**Subject: Engine Wire Harness Chafing / IPC Gauges Sweep / IPC Warning Message / SES/Check Engine/MIL / No Start / No Crank / Runs Rough / Stalls / Reduced Engine Power / Various DTCs**

*This bulletin replaces PIT5677E, PIT5713A, PIT5751C and PIT5742. Please discard PIT5677E, PIT5713A, PIT5751C and PIT5742.*

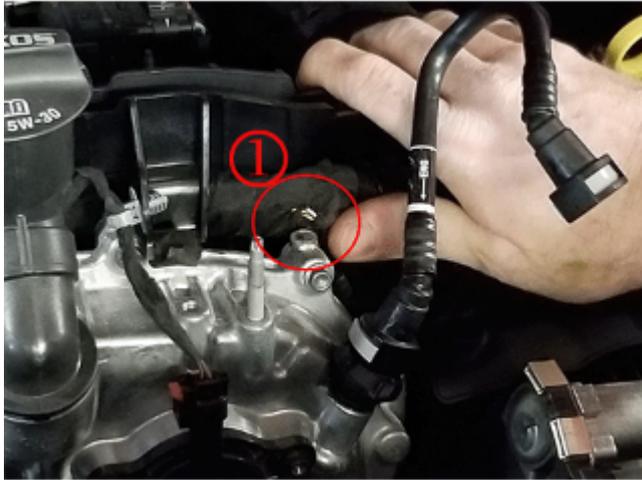
Inspect the engine harness as it crosses over top of the Camshaft Carrier Cover.

Harness damage can occur at any point across the Camshaft Carrier Cover.

Wiring harness rub through on a cam cover stud/bolt.

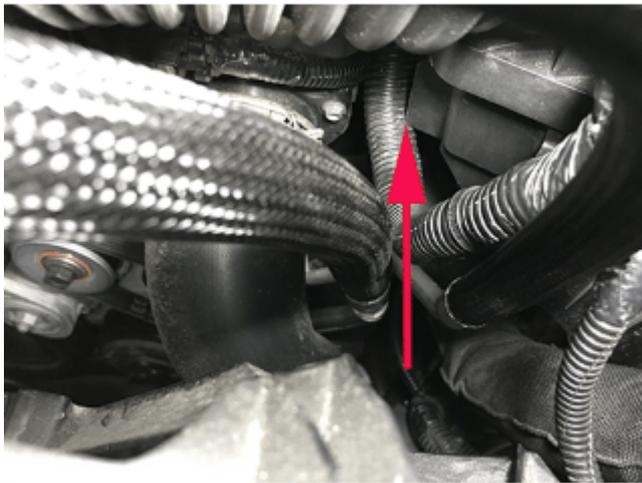
Example of engine wiring harness damage at Camshaft Carrier Cover shown below.

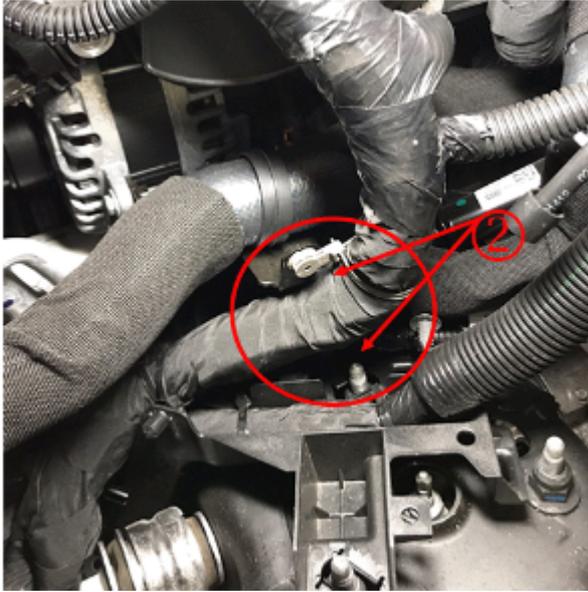
Inspect the engine harness at the Lower Air Cleaner Housing as shown below.

Example of engine harness damage, Lower Air Cleaner Housing removed shown below.

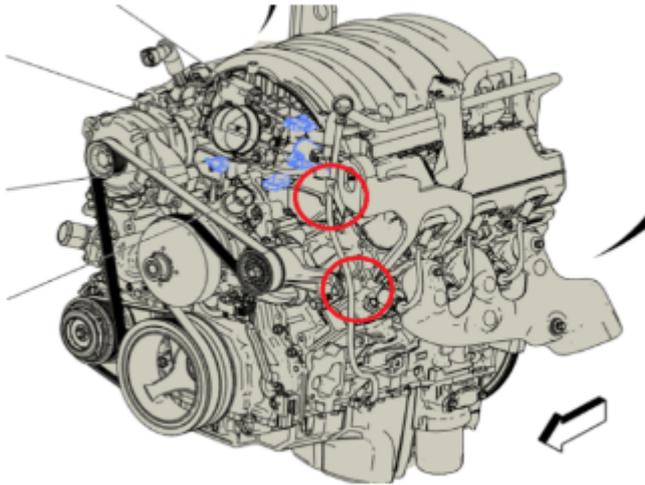
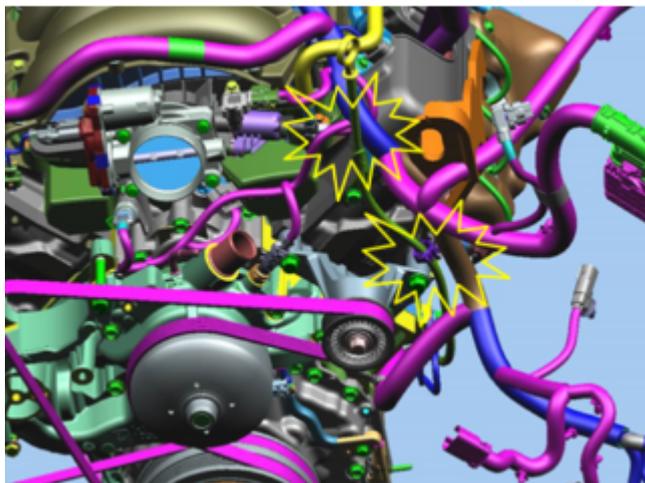
These concerns could be caused by engine wiring harness chafe on underhood components at various locations such as: Front corner of the left-hand cylinder head, drive belt idler pulley bracket, or oil dipstick bracket; noted by the circled and starred areas in the graphics above.

This harness chaffing could cause shorting of any number of circuits to ground. Due to the number of circuits in the harness, there is a wide variety of different symptoms that could occur depending on which circuit(s) are damaged.

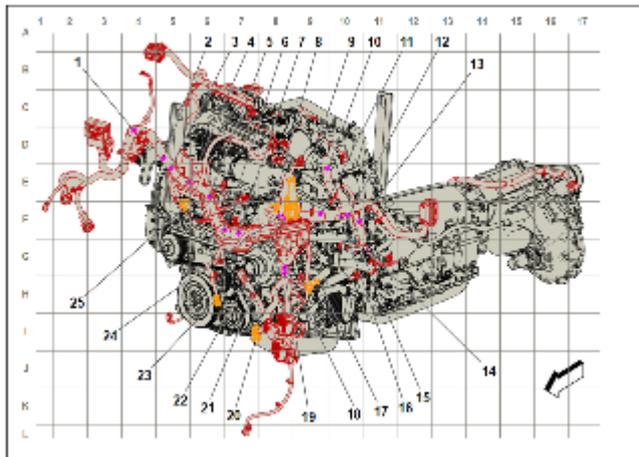
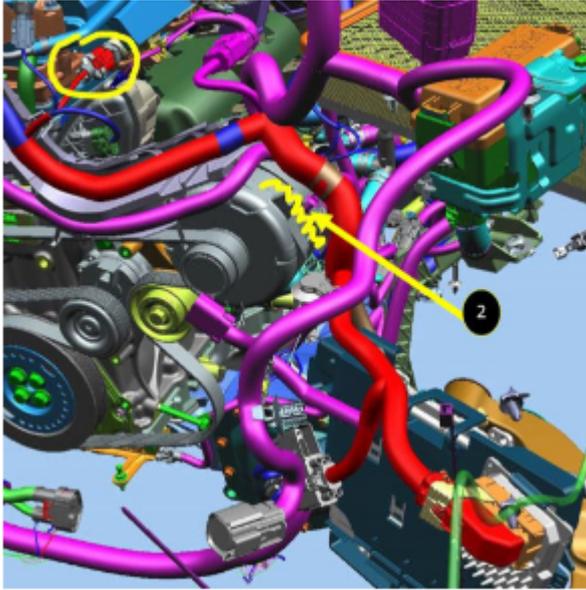
1. The engine harness pinched/shorted/chaffed at grid coordinates G-8, as shown above. This location is approximately 18 inches from the ECM connectors (1) and on top of the generator (2), as shown below. Due to the number of circuits in the harness, there is a wide variety of different symptoms that could occur, depending on which circuit(s) are damaged.

Inspect areas designated by the graphics and callouts in Cause #3. In many cases, the ECM has been unnecessarily replaced for these concerns. Please thoroughly inspect the areas shown above and follow published SI diagnostics before any parts are replaced. If any concerns are found, then follow SI Wiring and Connector repair instructions to correct the concern.

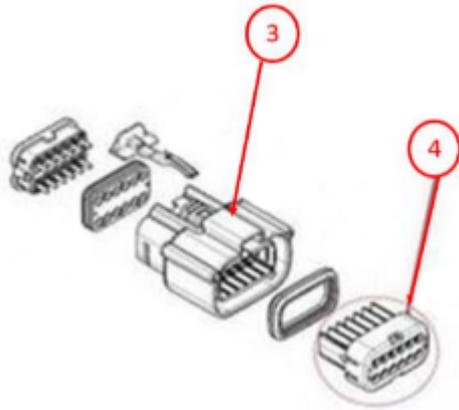
2. The engine harness shorted/chaffed at grid coordinates C-9, as shown above. The engine harness could be shorted out on the PVC hose clamp at the crankcase pressure regulator, as shown below (6). This is located approximately 4 inches from the crankcase sensor connector pigtail harness breakout.

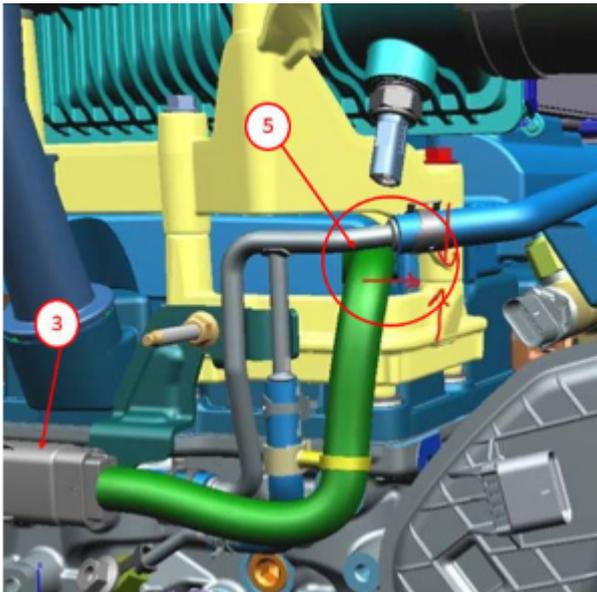
1. Inspect for poor terminal tension at connector X160, shown in the grid above, as callout 25. While inspecting X160 make sure the terminal locking feature (4), shown below, is not missing.

2. Inspect the fuel injector connectors to make sure they are fully connected/seated.
3. Inspect the fuel injector wiring harness near the X160 connector (3) for being pinched/shorted/chaffed, as shown below (5).

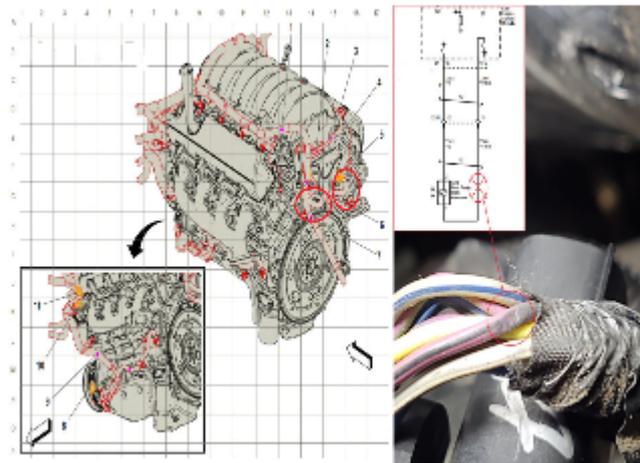
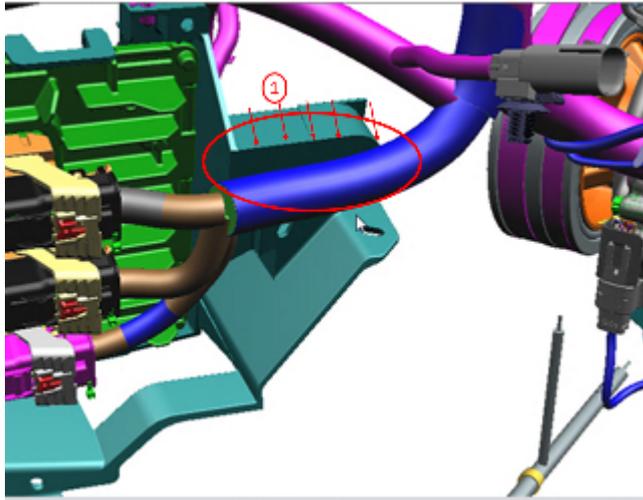
Examples of extreme wire chaffing.

An example of firewall insulator chaffing

Other areas of concern.

The cause of the condition may be an engine wire harness clip was removed during production due to ergonomic issues (hand clearance and branch stiffness). This led to an uncontrolled branch that came into contact with a sharp edge (1) & (2) on the ECM/TCM bracket, driver side upper control arm, and/or shock tower and caused chaffing during engine vibration and roll.

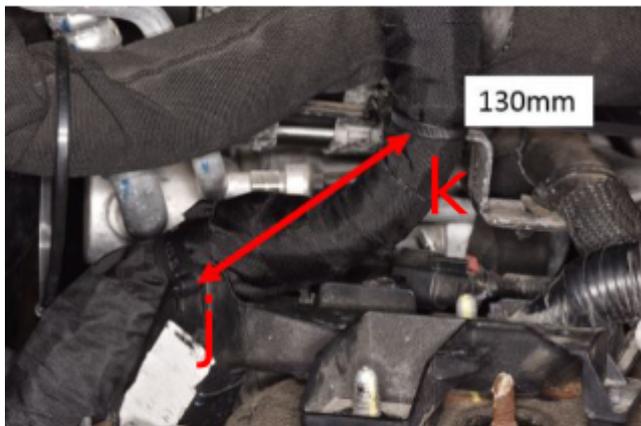
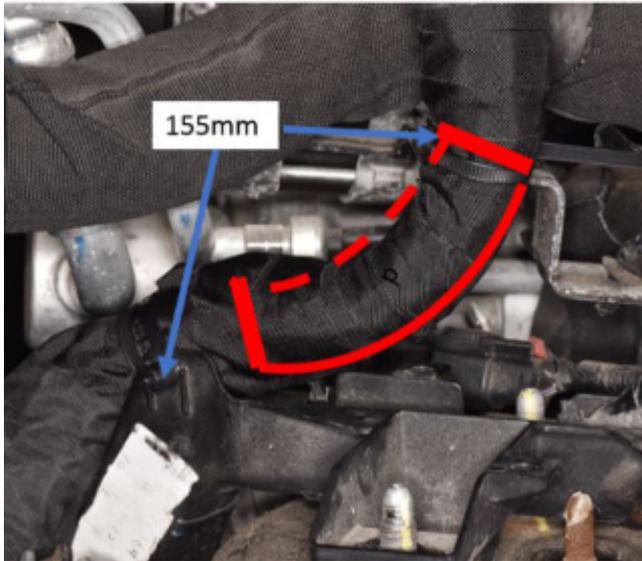
Protect the engine wiring harness from future damage at Generator Bracket.

Zip Tie style Fir Tree Clips are located on the plastic Channel at #1 and on the Generator Bracket at #2 shown below.

Measure up 155 mm from the Zip Tie style Fir Tree Clip located on the plastic Channel.

Install the Kevlar Velcro Sleeve PN 84820678 155 mm up the engine wiring harness as shown below to ensure that the sleeve extends 25mm above the Zip Tie style Fir Tree Clip located at the Generator Bracket as shown below.

Tape both ends of the Kevlar Velcro Sleeve with Woven Polyester (PET) Electrical/Anti-Abrasive Tape using KENT® AUTOMOTIVE 1089482 to secure in place.

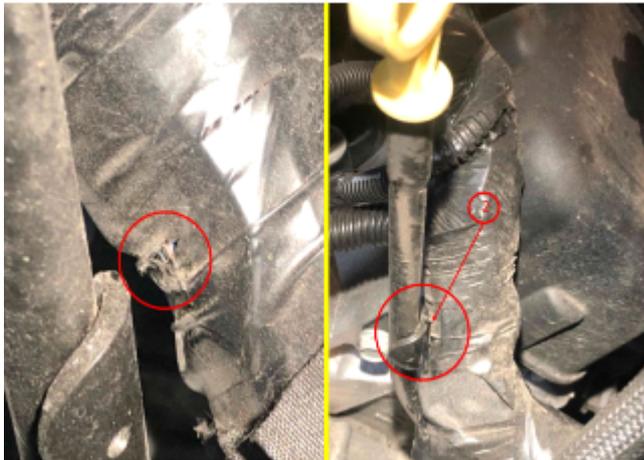
**Note:** The first graphic below is a before, and after (2), repair example of harness chaffing at the Oil Dipstick bracket.

To correct this concern, repair the damaged wiring following the SI wire-to-wire repair procedures. Once repaired, protect, and reposition the engine wiring harness to prevent future harness damage.

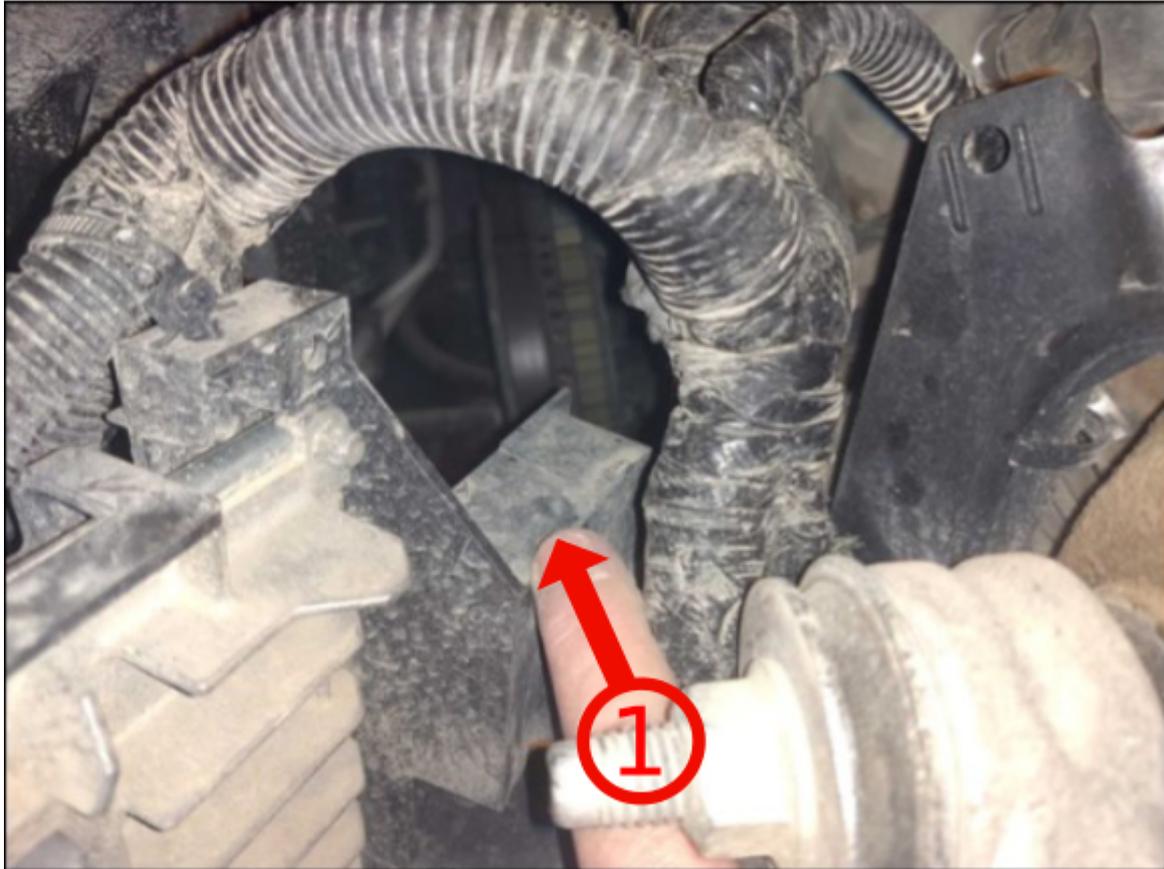
3. Locate the three contact points where the wire harness is chaffing, the ECM/TCM black bracket (1), the upper control arm (2), and the shock tower bolt (3).

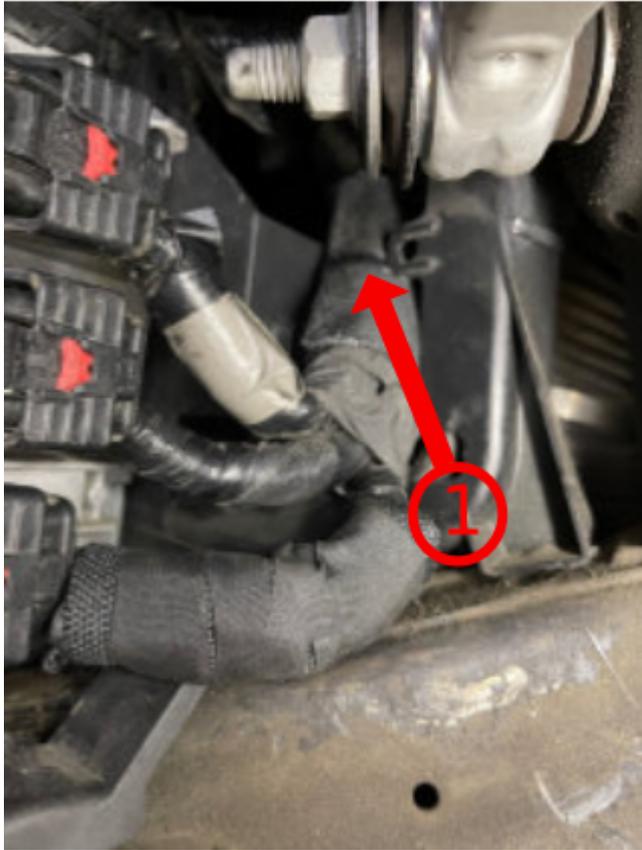
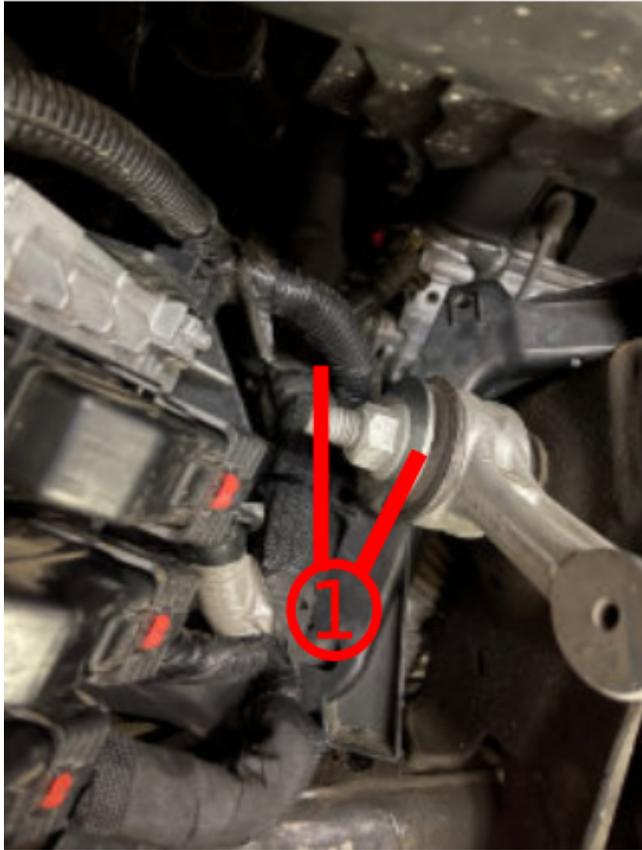
4. At the ECM/TCM bracket, locate the wire harness laying against the ledge (1).

5. Wrap the wire harness with the shorter Engine Harness Sleeve then utilizing zip ties and two small holes in the bracket (1).

6. Secure the harness snug to the bracket to prevent movement.

7. At the upper control arm (1), secure the harness away from control arm (example above shows harness in the correct position, unwrapped).

8. Wrap the harness in the shorter Engine Harness Sleeve then wrap with anti-abrasion tape secure it to the harness clip above the ECM/TCM bracket (1) to keep out of the way of the upper control arm.

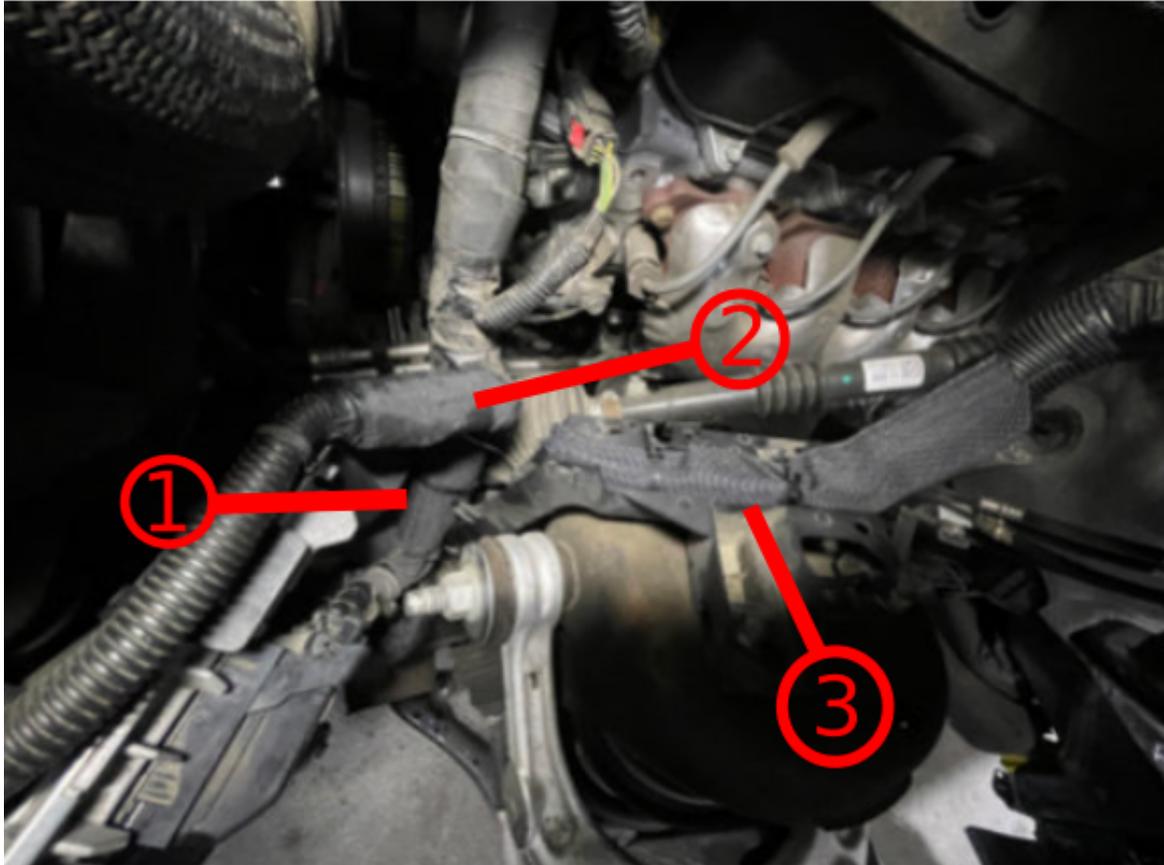
9. At the shock tower point there is a wire harness canal (1).

10. Using the long Engine Harness Sleeve, wrap the harness and secure it snug to the canal using zip-ties.

11. Verify the wire harness is wrapped and secured at all three points, the ECM/TCM Bracket (1), Upper Control Arm (2), and the Shock Tower (3). Then reassemble the vehicle.
12. Reinstall the front wheelhouse liner and tire and wheel. Refer to *Front Wheelhouse Liner Replacement* and *Tire and Wheel Removal and Installation* in SI.
13. Remove the support and lower the vehicle.
